DART AEROSPACE LTD	Work Order:	29403
Description: Bracket	Part Number:	D2803-1
Inspection Dwg: D2803 Rev: B		Page 1 of 1

DESIG	CP	DRAWN BY	DART AEROS HAWKESBURY, ONTA	
CHEC	KED M	APPROVED M	DRAWING NO.	REV. B
	#	#	D2803	SHEET 1 OF 2
DATE		<u> </u>	TILE	SCALE
 04.1	1.22		STA 84 BRACKET	1:3
 Α		00.11.07	NEW ISSUE

Subject: D2803 Bracket

D2803 bracket for the folding steps:

DESIGN	DRAWN BY	DART AEROSPACE LTD HAWKESBURY, ONTARIO, CANADA	
CHECKED	APPROVED ,	DRAWING NO.	REV. B
*	4	D2803	SHEET 2 OF 2
DATE		TITLE	SCALE
04.11.22		STA 84 BRACKET	1:3

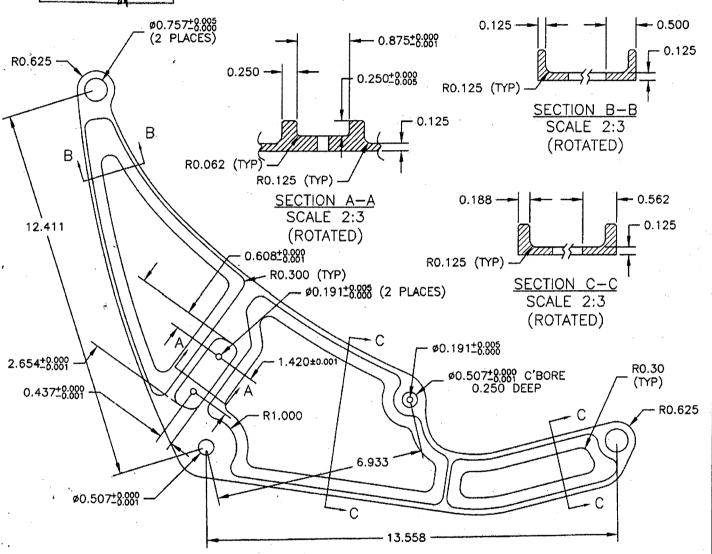
Description of NC		Corrective Action Section B		Verification		
DATE STEP		Section A	Initial Chief Eng	Action Description Chief Eng	Sign & Date	Section C	Approval Chief Eng	Approval QC Inspector
ottoil®	# 3.0	tool & fellout of 1001 changes during bolchange put a o.oze" Deep gouse	lasion	Scrap : distroy. Give to eng. for test fitting projects No replace, I.D. part AS SCRAP.		of of all	OSI OUL	81.1040
67.61.19	3	POCKET FIR STUP IS 0,872 WIDE INSTEAD OF 0.875±0.001	9, v1, 15	PARTS ARE ACCEPTABLE AS LONG AS DZBOS STOP CAN BE SUCCESFULLY PRESS	J.L 04/61/19	A017	67.61.15 pr 081642	Mary
oHoHu	\$9,0	Test Por 0875 palat	1	DZ805-1. Por part washing	<u>M4</u>	जीकीह	Cosiols	07/07/14

NCR:		W	WORK ORDER NON-CONFORMANCE (NCR)					
		Description of NC		Corrective Action Section B	Verification	Approval	Approval	
DATE	STEP	Section A	Initial Chief Eng	Action Description Chief Eng	Sign & Date	Section C	Chief Eng	Approval QC Inspector
\ \.\!\.	3	- Sport pocket for stopper is too deep, tool pulled		See Previous page.	J-h	·		
07104	,	dimension .250 to controller	. <u></u>	See Previous page.	0.500			
			,					
				;	. 24		,	<i>*</i>

The pockets for the stop should be 0.875+0.000/-0.001 wide to fit a 0.875+0.001/-0.000 wide D2805 stop.

The pockets now (qty 13) are 0.872, so there would be an extra 0.002 of press fit. They said they should be able to re-machine, but they aren't too keen on doing so (mainly from the time it would take). I suspect there's also a danger of scrapping them if they mess something up in the re-machine.

I am thinking that we could try press fitting them regardless (we'd try try just one first!). We'd have to make sure the holes still allow the AN3 bolts to pass through. Would you accept this deviation if the press fit is acceptable?

Yes. Proceed as you have outlined below.
